UFCA FLORIDA GULF COAST HOSPITAL
Outpatient Rehabilitation & Diagnostic Center
DIAGNOSTICS MRI
ADDITION

HCA Diagnostic Center MRI Addition Bid Addendum No. 1

Date: 04/25/25

DAG Project #: 24107

SCALE: 1/4" = 1'-0"	NEW RAMP @ VESTIBULE
---------------------	----------------------

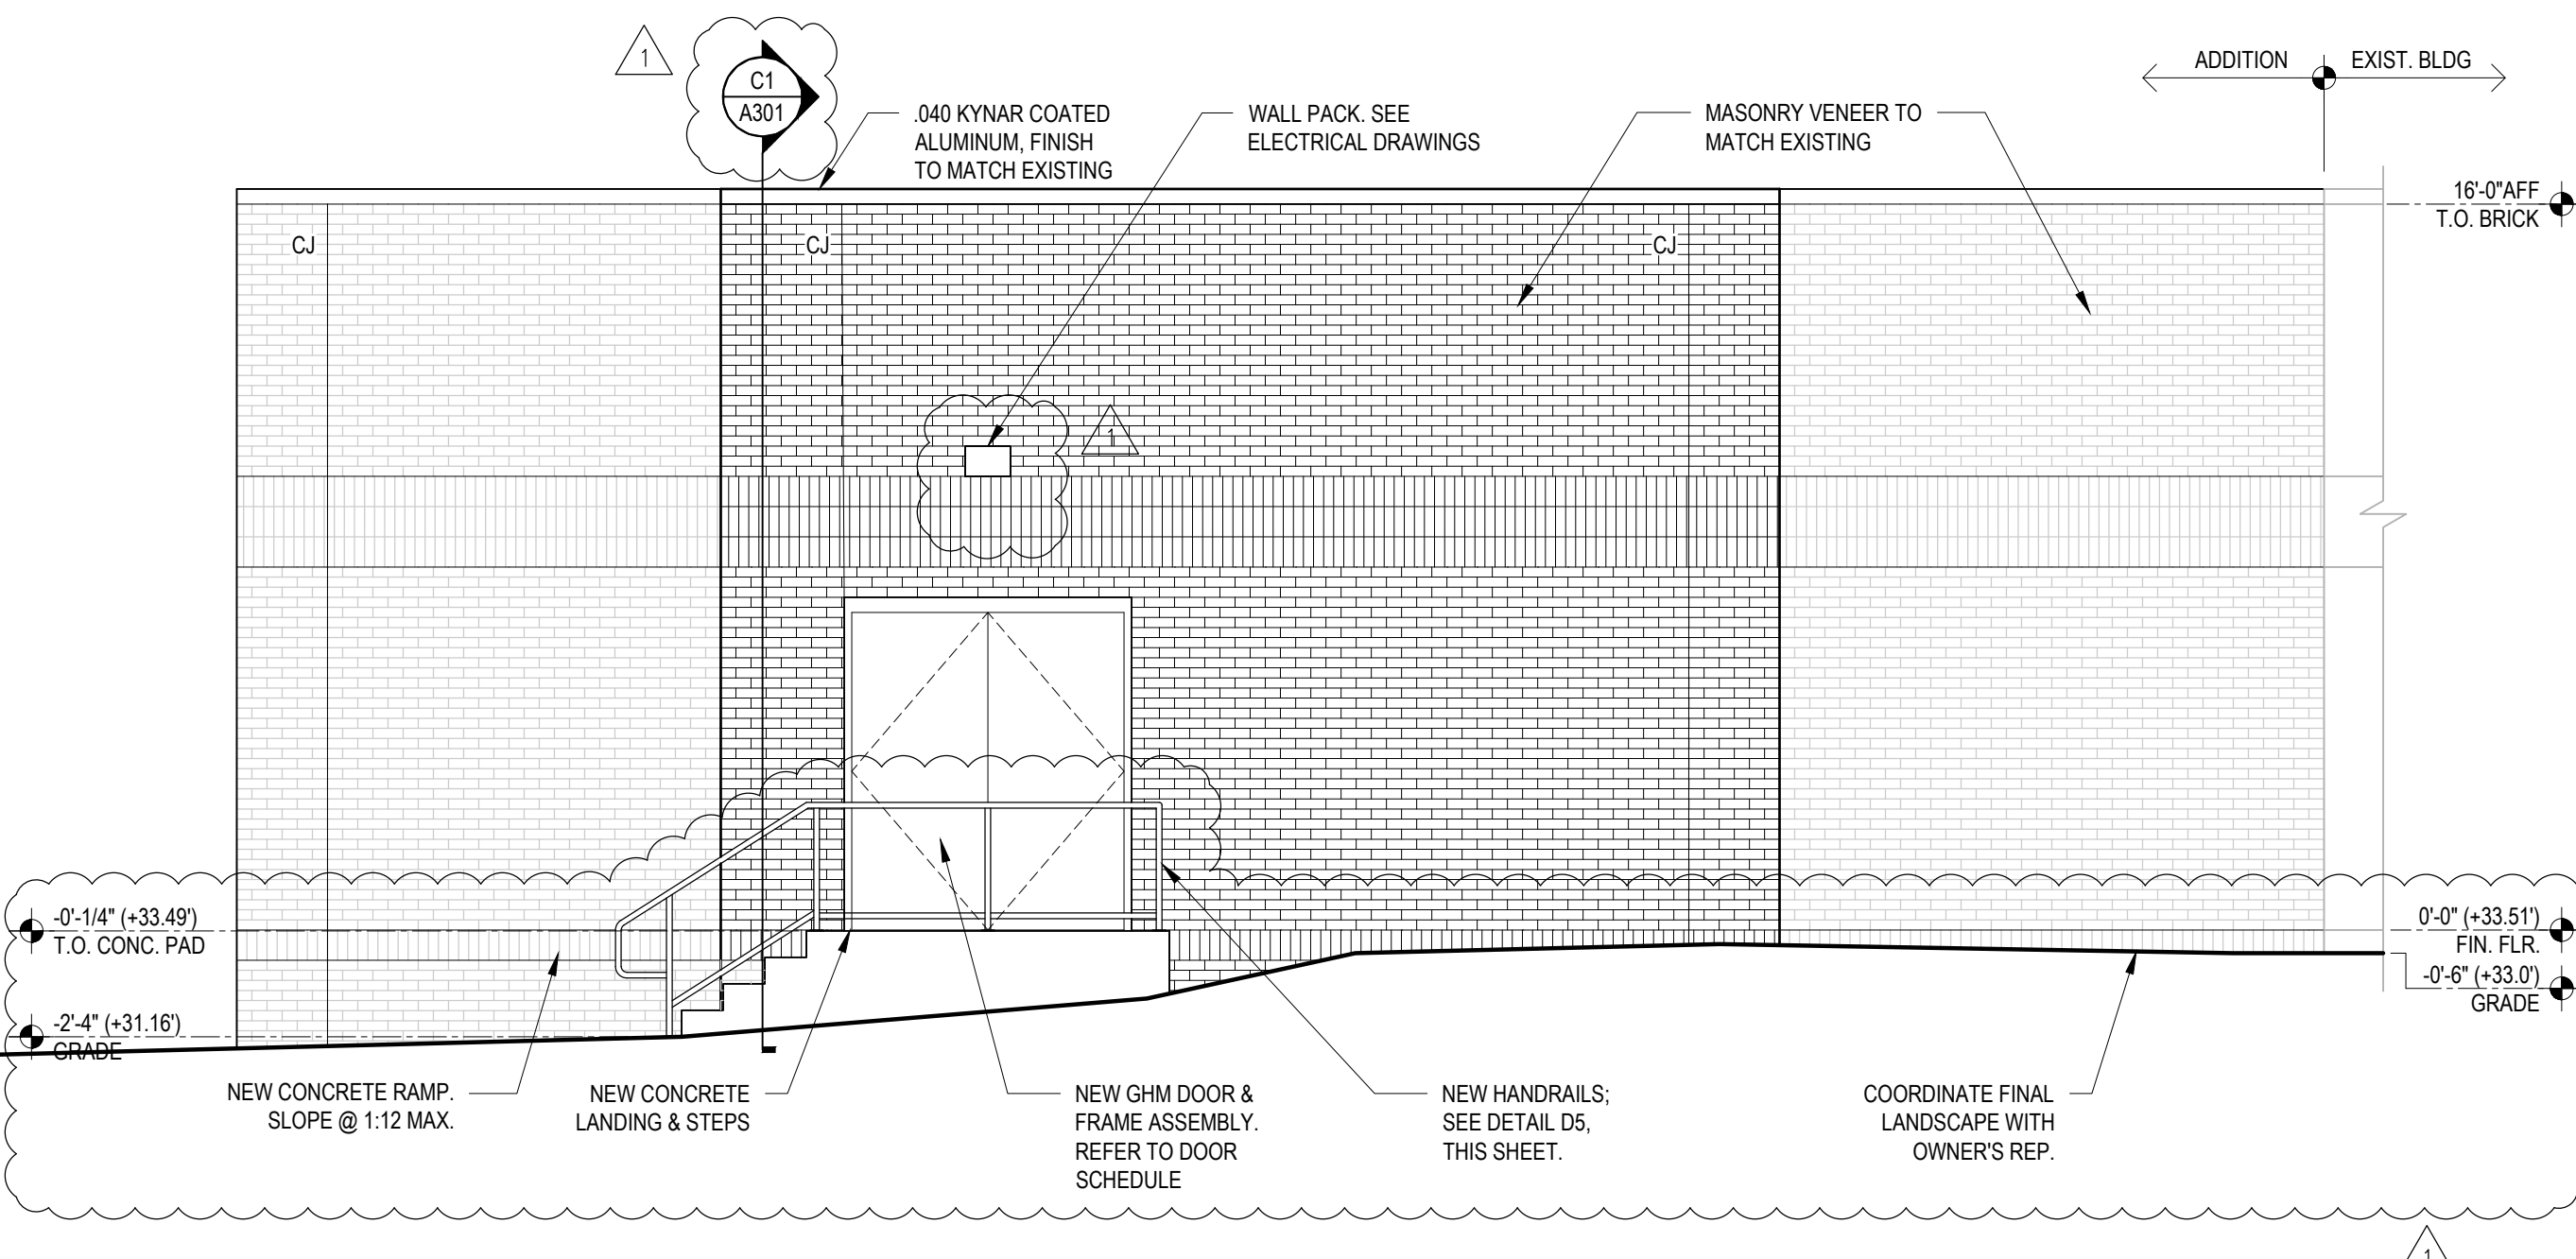
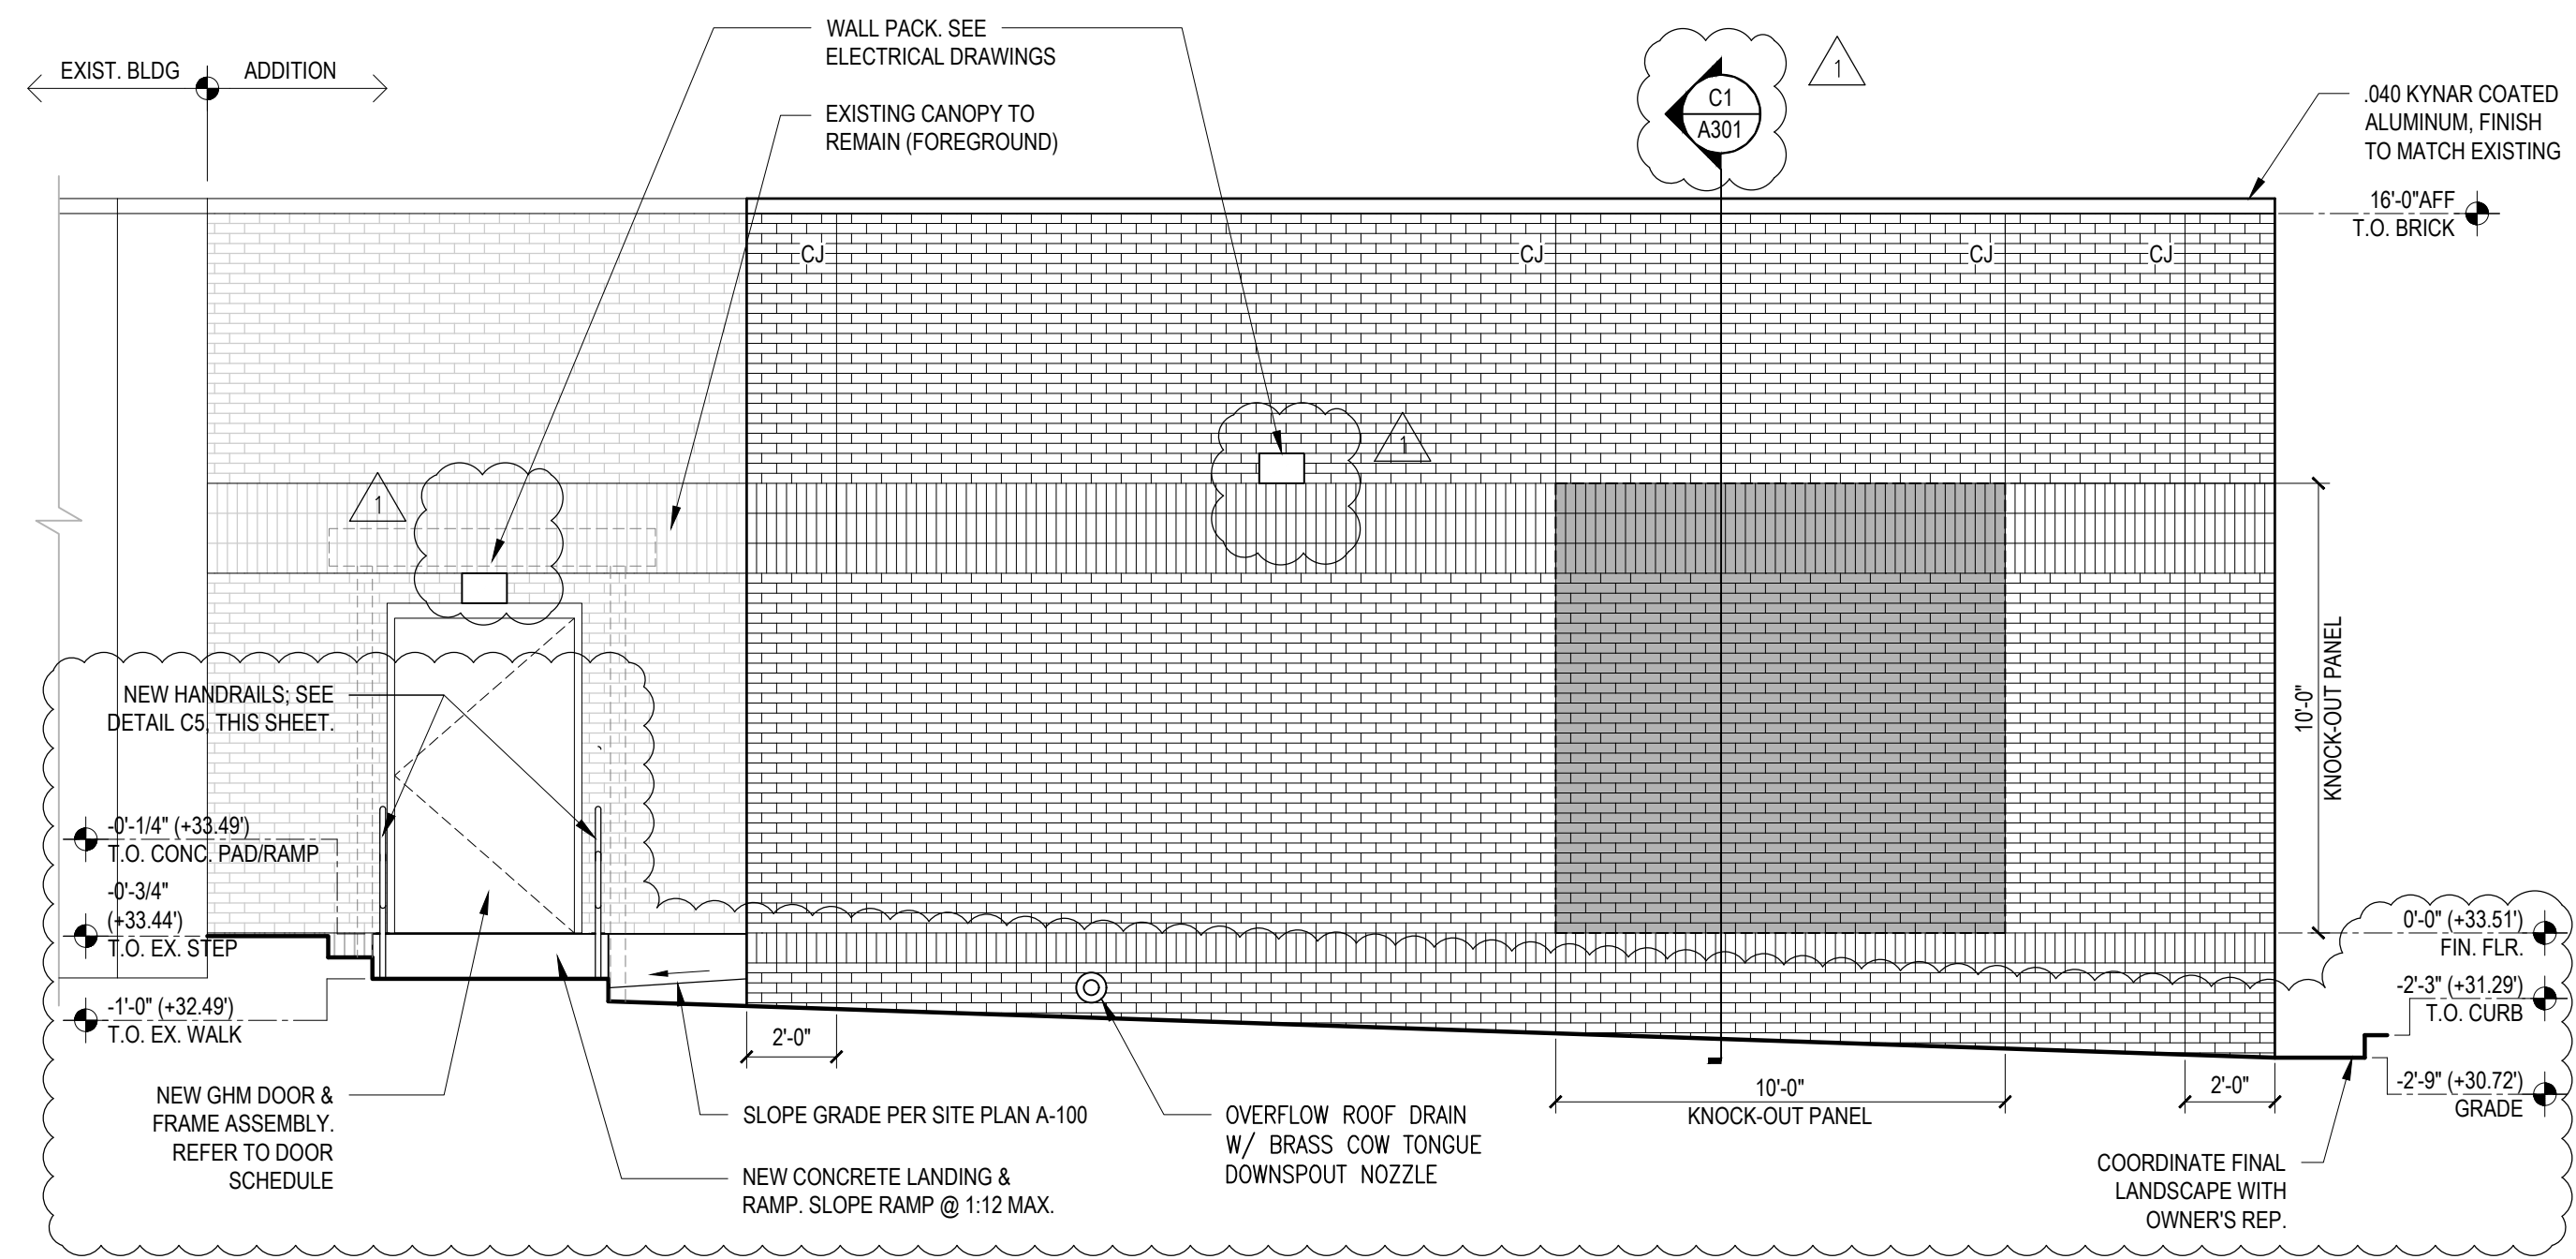
A-201 DETAIL A1

- CHANGED BUILDING SECTION CALLOUT – CHANGED FROM "A1/A301" TO "C1/A301"
- ADDED GRADE ELEVATIONS FROM SITE PLAN
- REMOVED RAMP FROM MECH. ROOM, ADDED STEPS & HANDRAIL
- RELOCATED EXTERIOR LIGHT FIXTURE TO ABOVE SOLDIER COURSE BRICK ABOVE DOORS.

C1 BUILDING SECTION
SCALE: 3/8" = 1'-0"

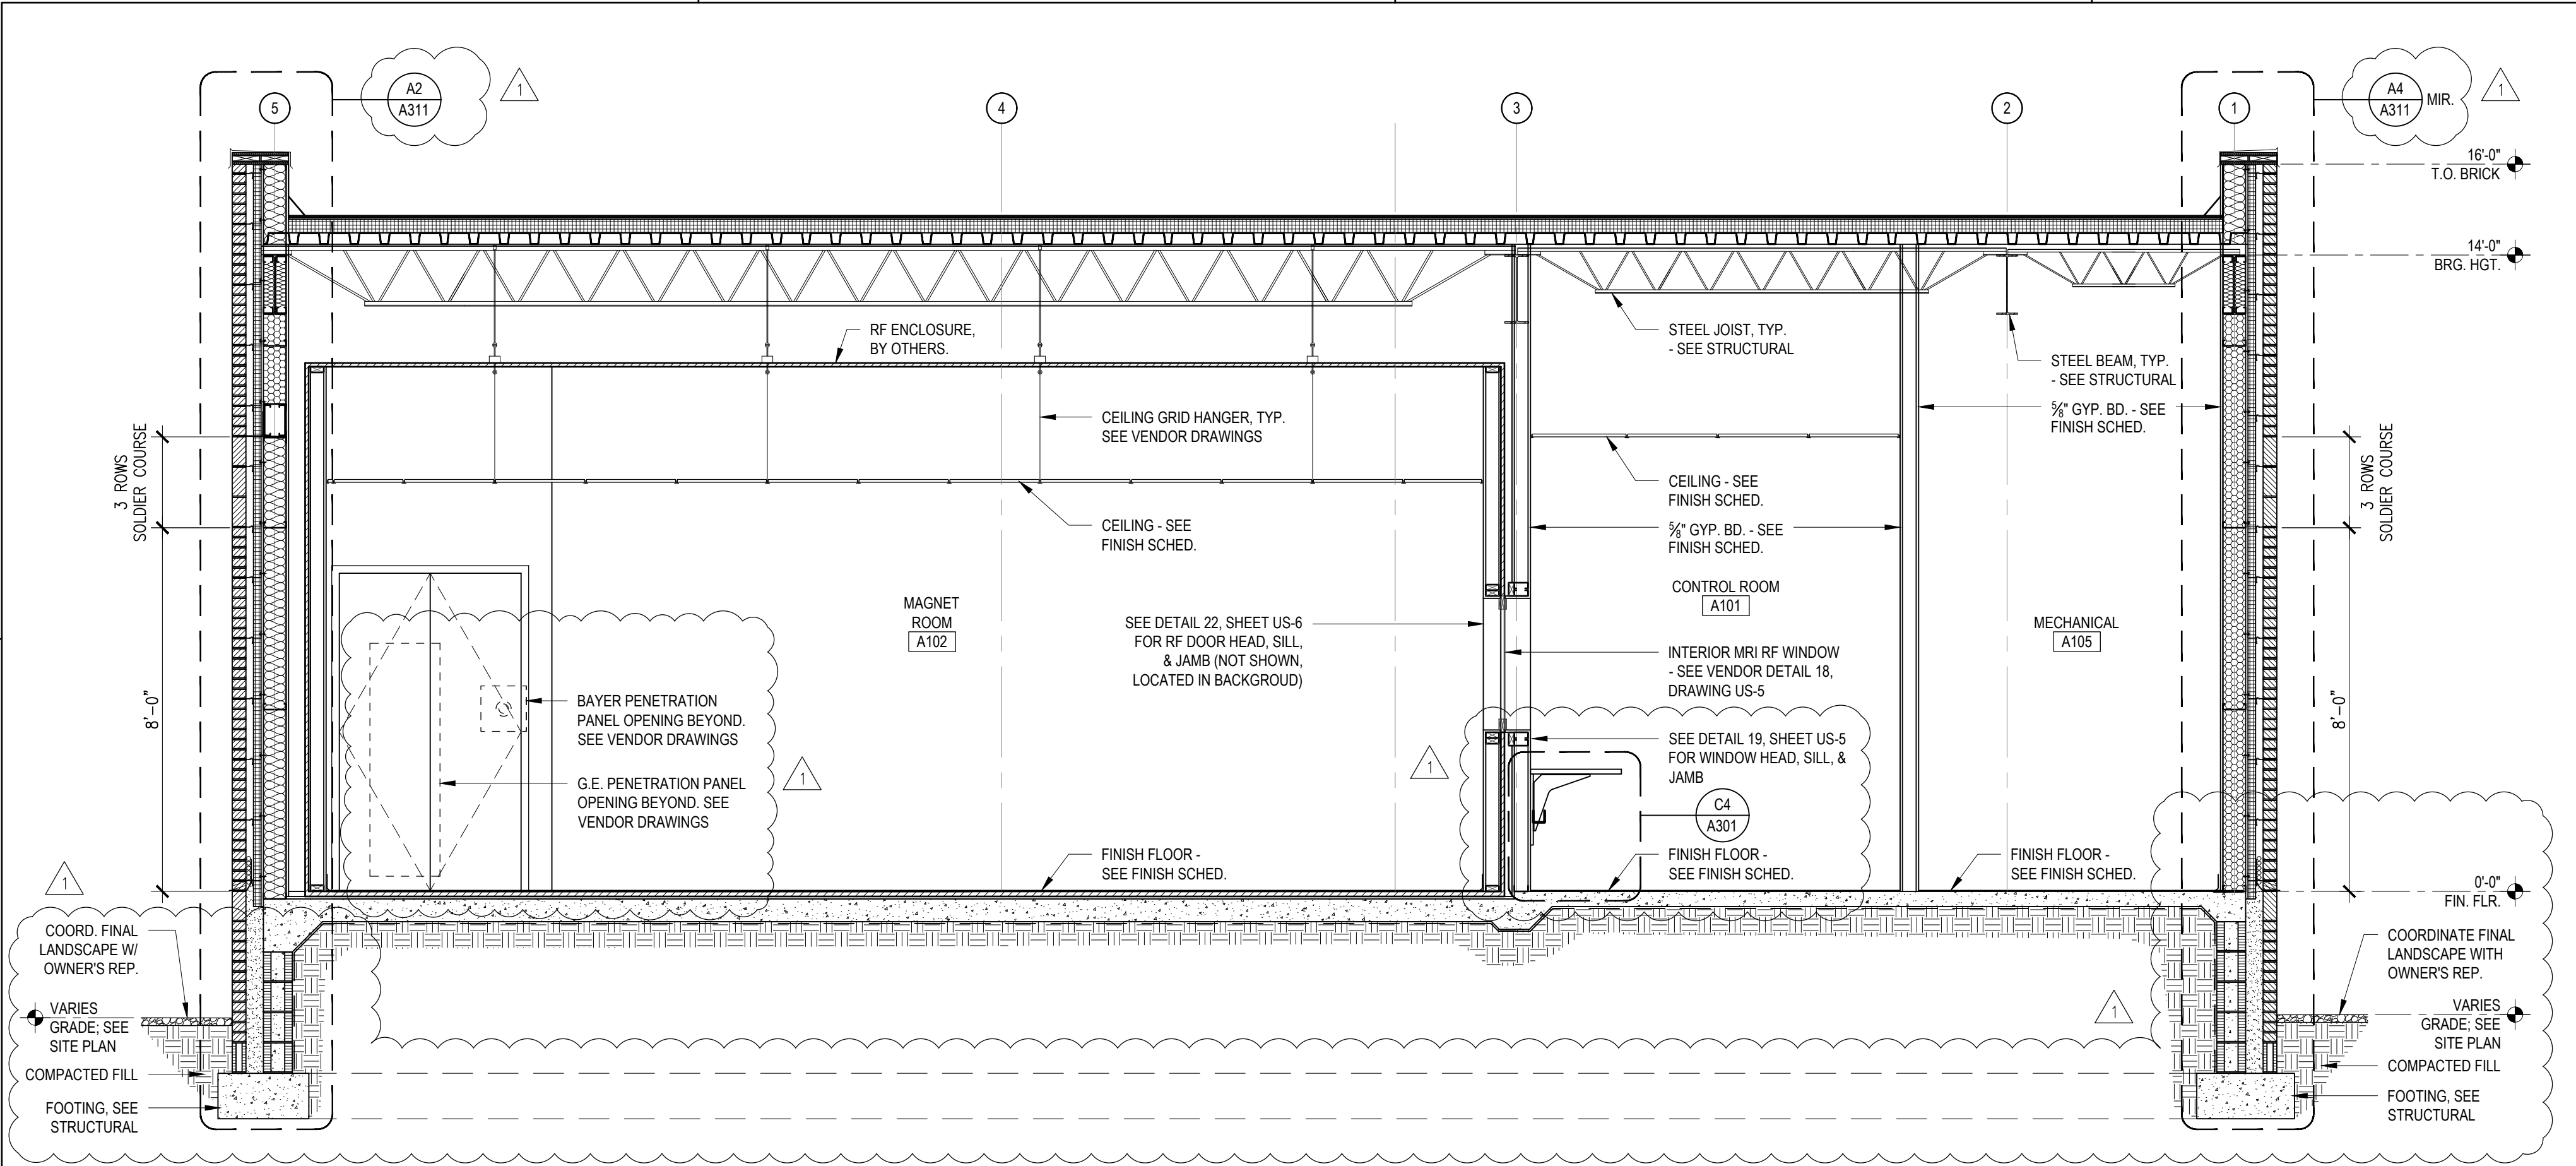
DETAIL C1

- CHANGED WALL SECTION CALLOUT FROM "A4/A312" TO "A2/A11" (SOUTH WALL)
- ADDED "SIM" TO "A4/A311" WALL SECTION CALLOUT. (NORTH WALL)
- ADDED MILLWORK TO CONTROL ROOM AND DETAIL CALL OUT "C4/A301"
- ADDED GRADE ELEVATIONS FROM SITE PLAN
- ADDED ADDITIONAL ROWS OF CMU TO ADJUST FOR ELEVATIONS
- ADDED BAYER PENETRATION PANEL IN CLOSET, MOVED GE PENETRATION PANEL TO THE SOUTH.
